Contract #: 04-0120F4Cty: SF/ALA Rte: 80 PM: 13.2/13.9File #: 99.28**WELDING INSPECTION REPORT****Resident Engineer:** Pursell, Gary**Address:** 333 Burma Road**City:** Oakland, CA 94607**Report No:** WIR-014455**Date Inspected:** 24-May-2010**Project Name:** SAS Superstructure**OSM Arrival Time:** 700**Prime Contractor:** American Bridge/Fluor Enterprises, a JV**OSM Departure Time:** 1900**Contractor:** Zhenhua Port Machinery Company, Ltd (ZPMC) Chanxing Island**Location:** Shanghai, China**CWI Name:** Mr. Zhou Cheng**CWI Present:** Yes No**Inspected CWI report:** Yes No N/A**Rod Oven in Use:** Yes No N/A**Electrode to specification:** Yes No N/A**Weld Procedures Followed:** Yes No N/A**Qualified Welders:** Yes No N/A**Verified Joint Fit-up:** Yes No N/A**Approved Drawings:** Yes No N/A**Approved WPS:** Yes No N/A**Delayed / Cancelled:** Yes No N/A**Bridge No:** 34-0006**Component:** OBG Segment 11CW**Summary of Items Observed:**

WELDING INSPECTION REPORT

Bay 19

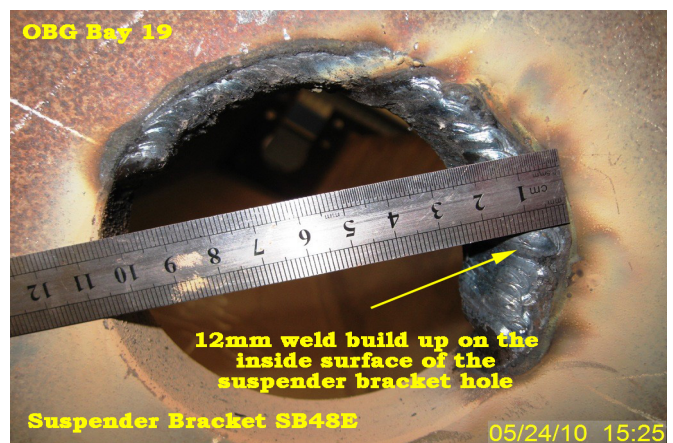
Description of Incident: During random in process observation of the fabrication of the OBG suspenders brackets, this Quality Assurance Inspector (QA) discovered ZPMC personnel have built up the inside surfaces of suspender rod hole with weld metal without the approval of the Engineer. The suspender bracket is designated as Stress Reversal Members (SRM) in the contract documents. The suspender bracket affected is identified on the material as SB48E. This condition exists on one (1) rod hole on above mentioned suspender bracket. This suspender bracket is located in OBG bay 19. For further information, please see the attached pictures.
